Subject: Joint Federal/State Application of Calvert Cliffs 3 Nuclear Project, LLC and UniStar Nuclear Operating Services, LLC, Calvert Cliffs Nuclear Power Plant Site, Lusby, Calvert County, Maryland, USACE Tracking No. NAB-2007-08123-M05

Application NAB-2007-08123-M05
Response to U.S. Army Corps of Engineers Information Request Dated 10/28/08
Calvert Cliffs 3 Project, LLC and UniStar Nuclear Operating Services, LLC
Revision 1 - February 27, 2009

Question 2

Thiokol Site Location	
	Figure Number: 1
<small>Prepared by/DWG: TWP 02-13-08 Checked by/DWG: JSC 02-13-08 Project Number:</small>

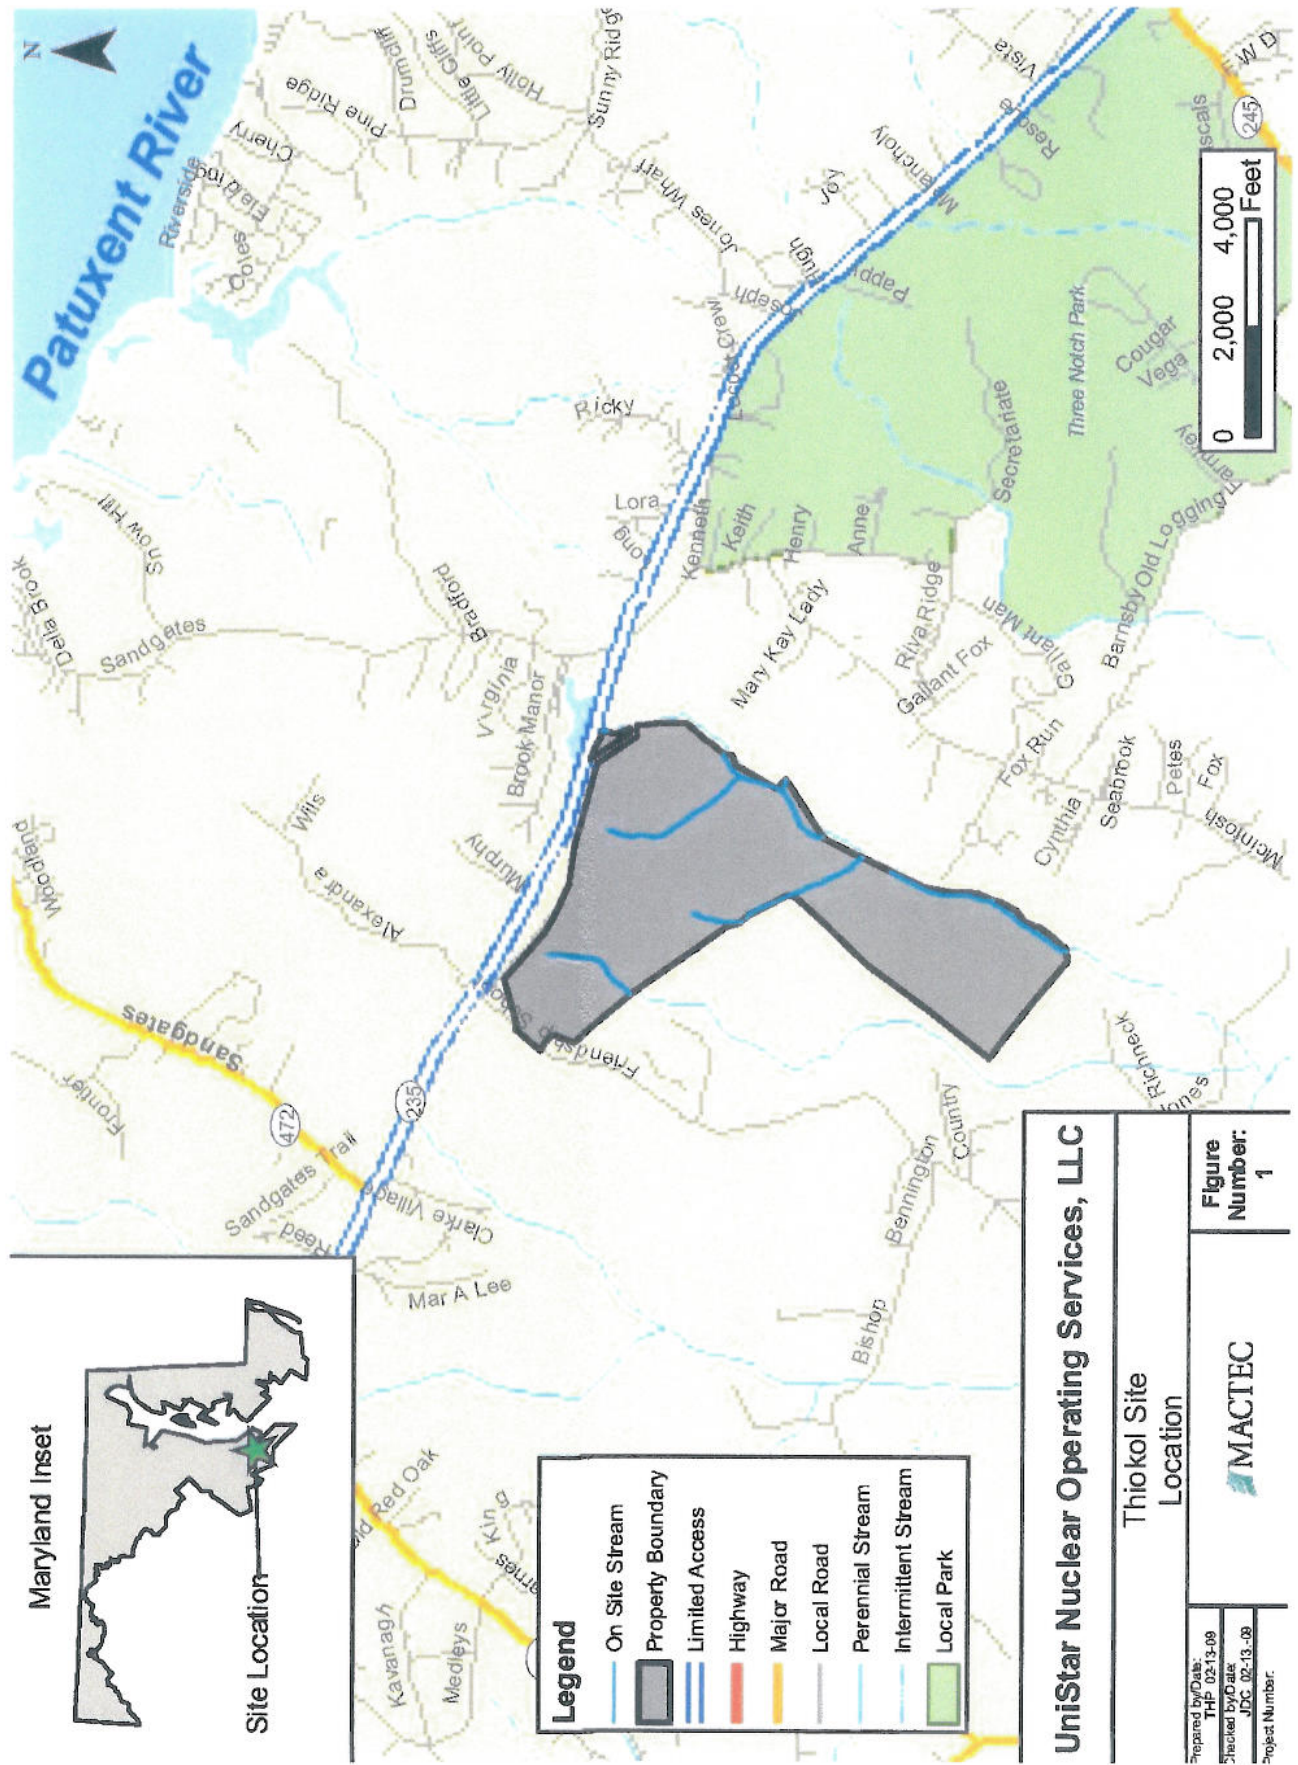
A detailed analysis of alternative locations for the proposed project or any of the alternate energy sources that would have less impact to wetlands and waterways. Data collected using resource mapping is acceptable and should be noted as appropriate in all evaluations.

The former Thiokol site which originally contained over 700 acres, now encompasses approximately 618 acres (ac) [250 hectares (ha)] of land in St. Mary's County, southern Maryland (Figure 1). The subject site is bordered by woodland, scattered agricultural parcels, Maryland Route 235 (northern boundary), and a forested wetland slough (portion of eastern boundary). Surface waters located on-site are Rich Neck Creek and Tom Swamp Run, including their interim tributaries, which flow through the heavily wooded property generally to the south and southwest toward the Potomac River. Surface waters near the former Thiokol site include the Patuxent River and Chesapeake Bay to the northeast and the Potomac River to the west.

The U.S. Fish and Wildlife Service (USFWS) National Wetlands Inventory (NWI) Wetlands Mapper (map resource database) was accessed to determine the total area of surface waters, including wetlands, present on the 618 acres (ac) [250 hectares (ha)] former Thiokol site. The area of the project including switch yard, power block and laydown would be approximately 257 acres (ac) 104 hectares (ha) exclusive of service roads and support facilities which would add to the total acreage required. In addition, 67 acres (ac) 27.114 (ha) of the site is identified as being a special reserve area that are to remain undisturbed. The NWI map data identifies that approximately 49.2 ac (19.9 ha) of non-tidal wetlands and approximately 14,411 linear feet (lf) (4,392 m) of stream channel occur within the site boundary. The majority of these stream channels are imbedded within the aforementioned forested wetland sloughs. The Federal Emergency Management Agency (FEMA) floodplain maps show no flood zones within the subject site (FEMA, 2009).
